**RE: SECTION 96(1A) MODIFICATION  
BLOCK 4S CENTRAL PARK (SSD5700)**

The modification relates to minor amendments to the public domain associated with the building, in the through-site link between Block 4S and Block 4N (note – no modifications to Block 4N SSD 6673). The modification includes the deletion of three planter boxes within the public domain in order to provide access and ventilation to High Voltage Cable Chamber room servicing Block 4N.

Figure 2 Comparison of approved (top) and proposed (bottom) public domain

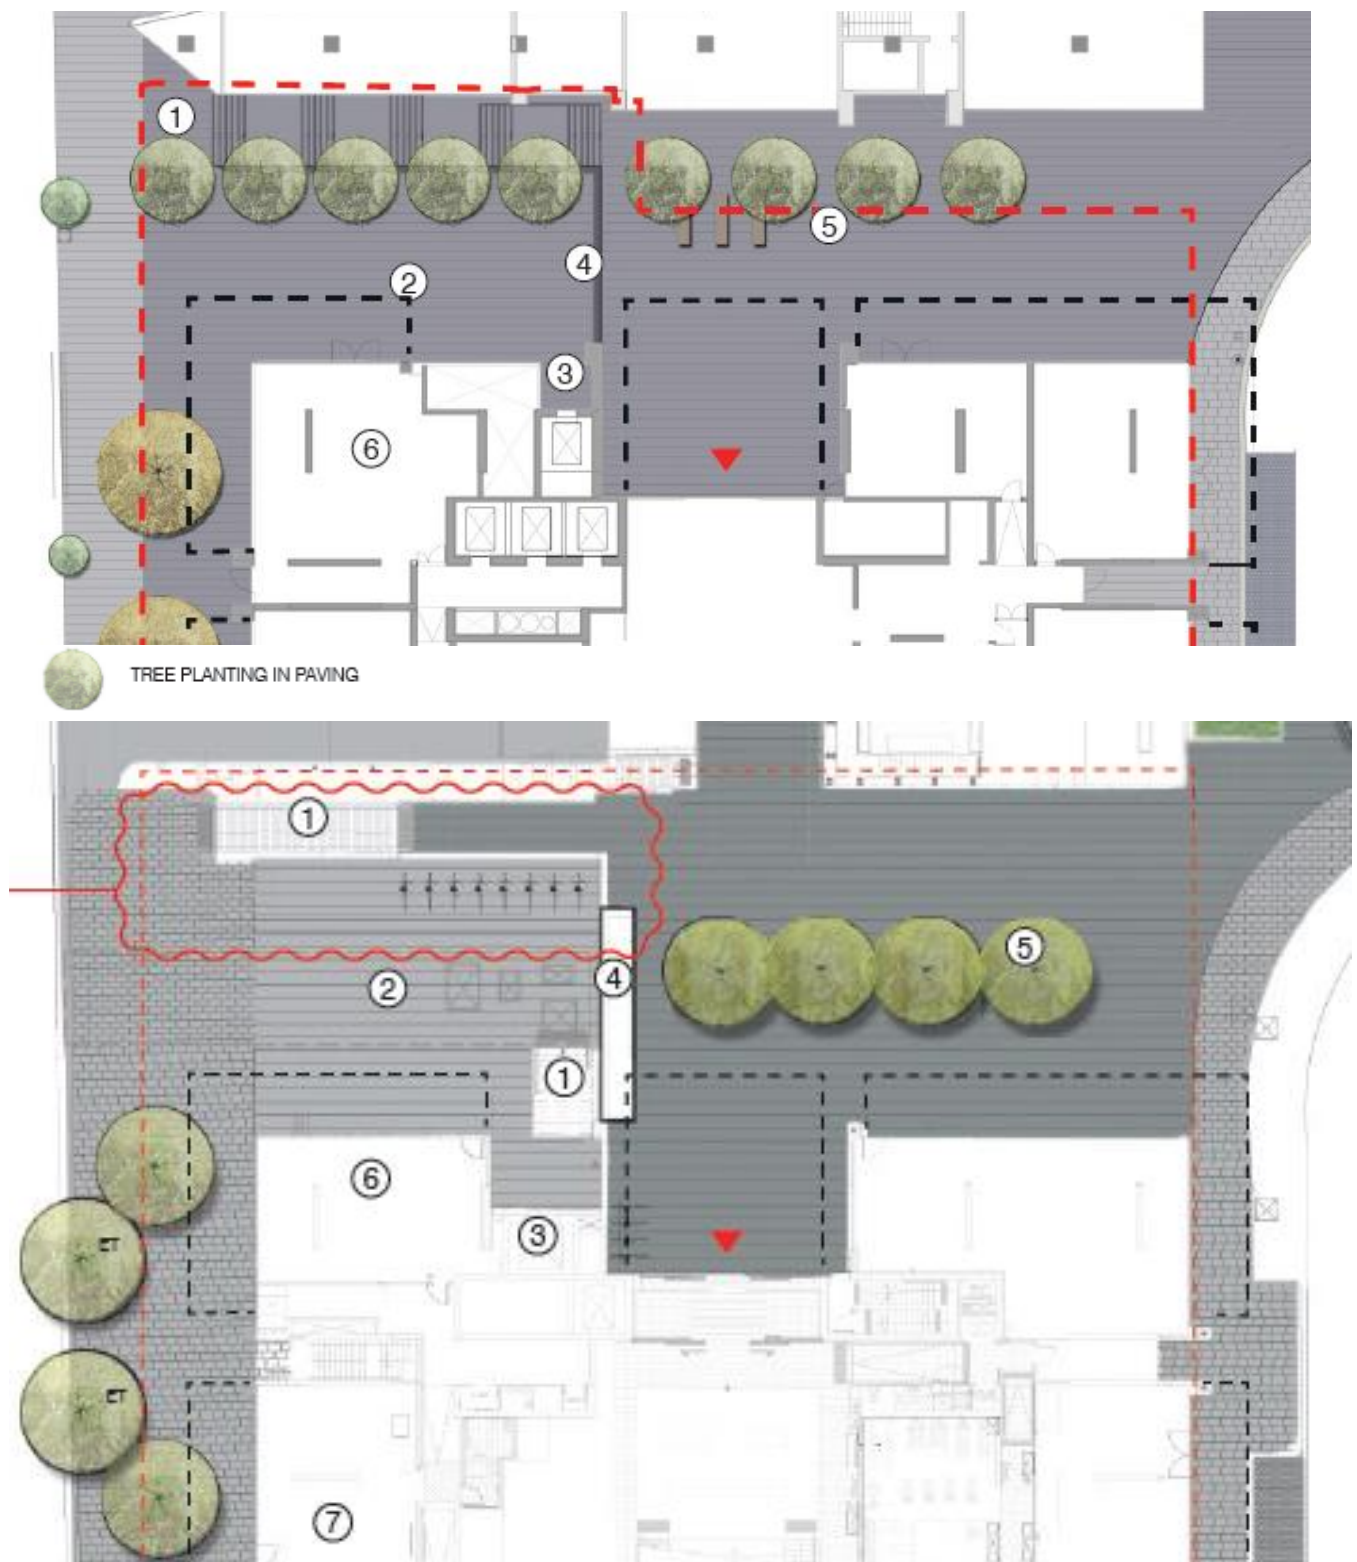
The modifications relate to amendments to the public domain and landscaping to the north of Block 4S, within the through-site link between Block 4N and Block 4S (connecting Abercrombie Street/Central Park Avenue). The modifications include the deletion of five planter boxes within the public domain. A location plan is shown at **Figure 1** and a comparison of the approved development and proposed modifications are shown at **Figure 2**.

The approval of Block 4N and its associated infrastructure has led to the need for access, ventilation and servicing requirements to the area. The High Voltage Cable (HVC) Chamber, located in the Block4N Basement required a path of egress and access hatch. Installation of planters as proposed in this area would fault this egress requirement to the Chamber (refer to **Figure 3**).

Figure 3 Illustrative diagram showing servicing and access requirements within through-site link

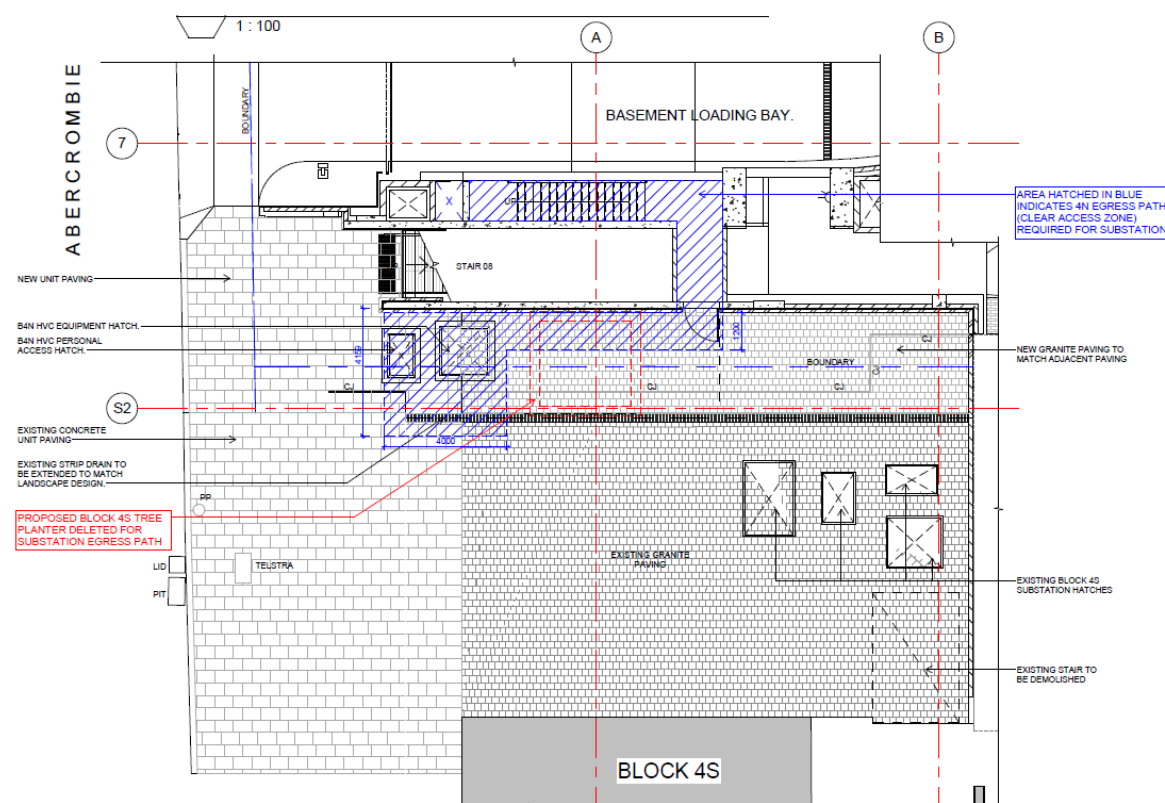
Additionally, any drainage to these planter boxes would encroach on agreed Ausgrid deed for servicing to the Block 4N HVC. Finally, relocating similar planters anywhere south of the current approved location will provide further complications, as no drainage would be able to be reticulated under the existing constructed slab, as there is another HVC (for 4S) in the location below.
